## PLAN REVISIONS

# BEECH TREE COVE LOT 12

MAIN LEVEL FLOOR PLAN

UPPER LEVEL FLOOR PLAN

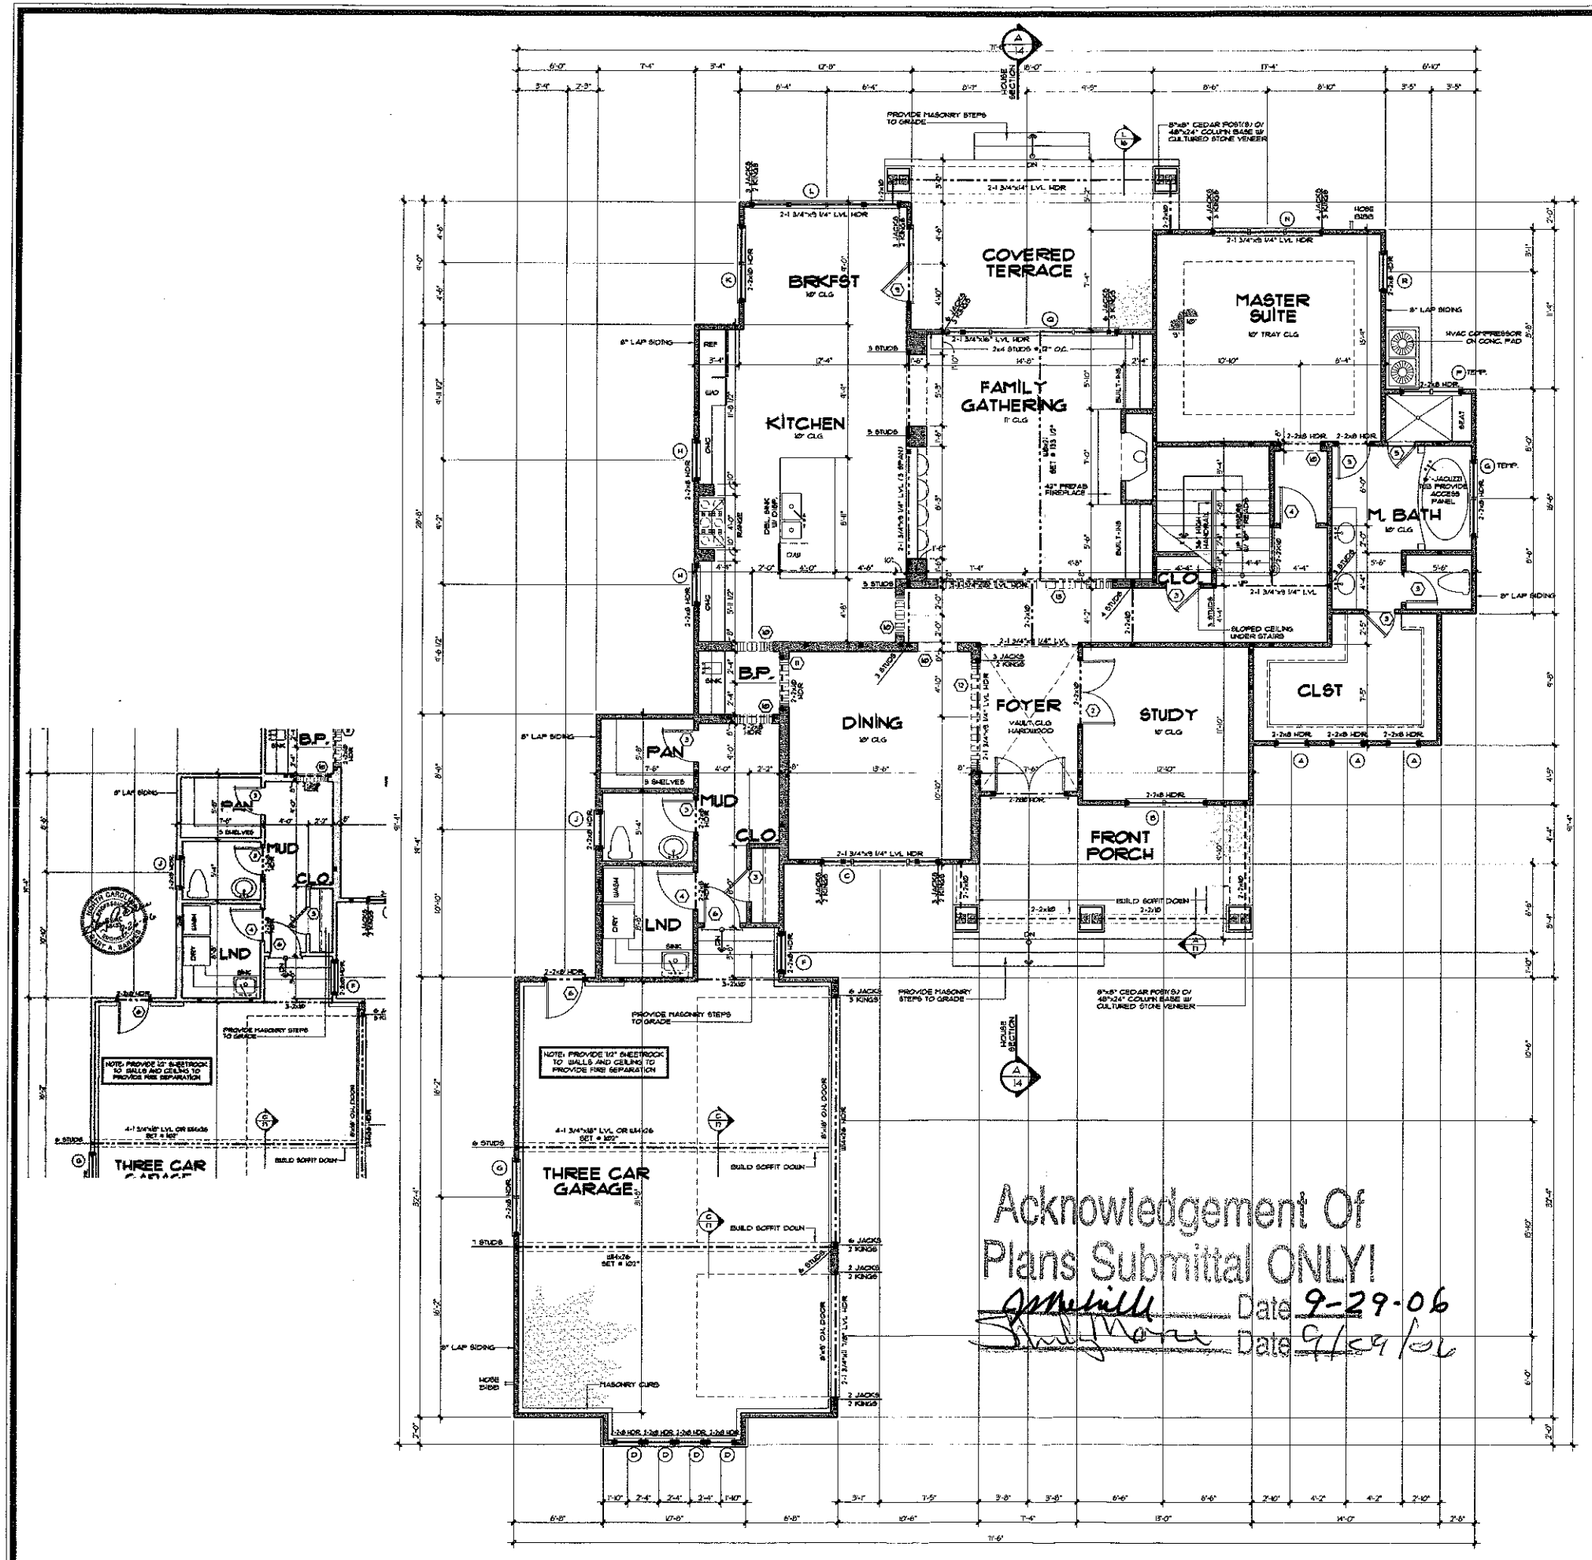
1. The House is to be moved to Lot 12
2. The garage is to be moved 18" to the right. The overall width of the structure will be 71'-6". All loading shall shift equally, to prevent change in load path.
3. The Garage to house connection at the mud room will move into the garage, per attached drawing.
4. A portion of the Laundry room ceiling will be furred down to 9' ceiling height, due to step down above.
5. All changes are dimensional, and do not require additional structure, from original plan with seal date of 9-7-06.

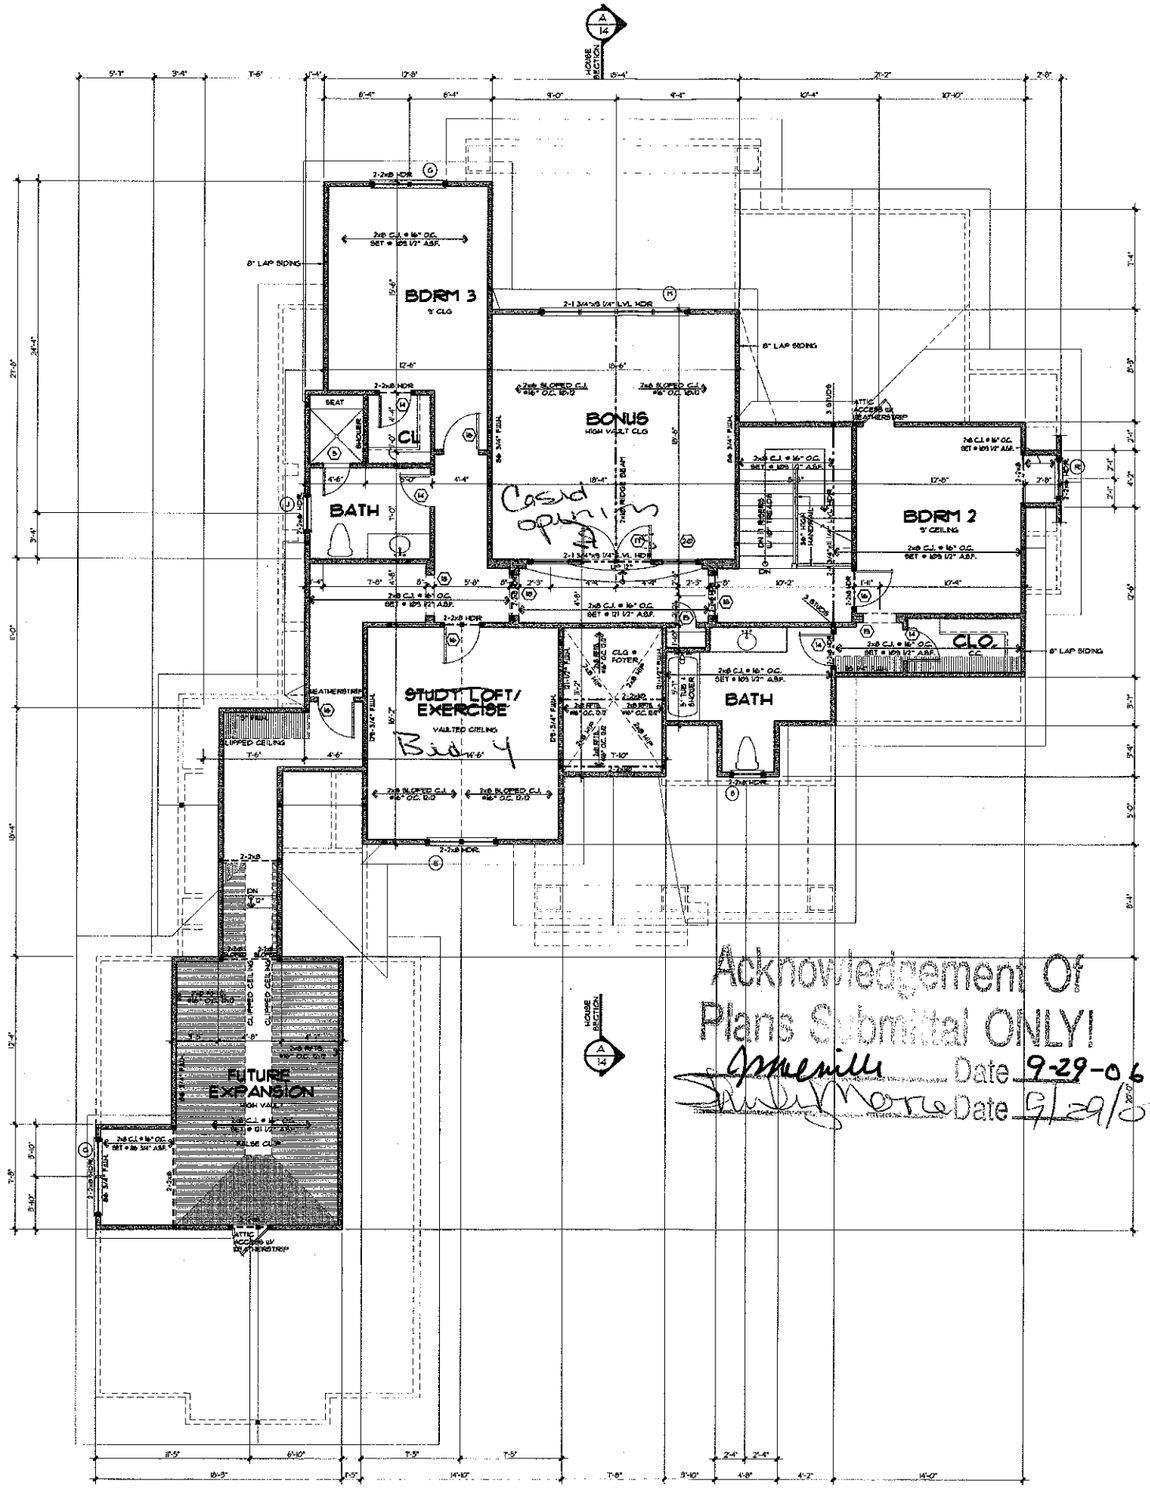
1. The House is to be moved to Lot 12
2. The garage is to be moved 18" to the right. The overall width of the structure will be 71'-6". All loading shall shift equally, to prevent change in load path.
3. The Garage to house connection at the mud room will move into the garage, per attached drawing.
4. A portion of the Laundry room ceiling will be furred down to 9' ceiling height, due to step down above.
5. All changes are dimensional, and do not require additional structure, from original plan with seal date of 9-7-06.
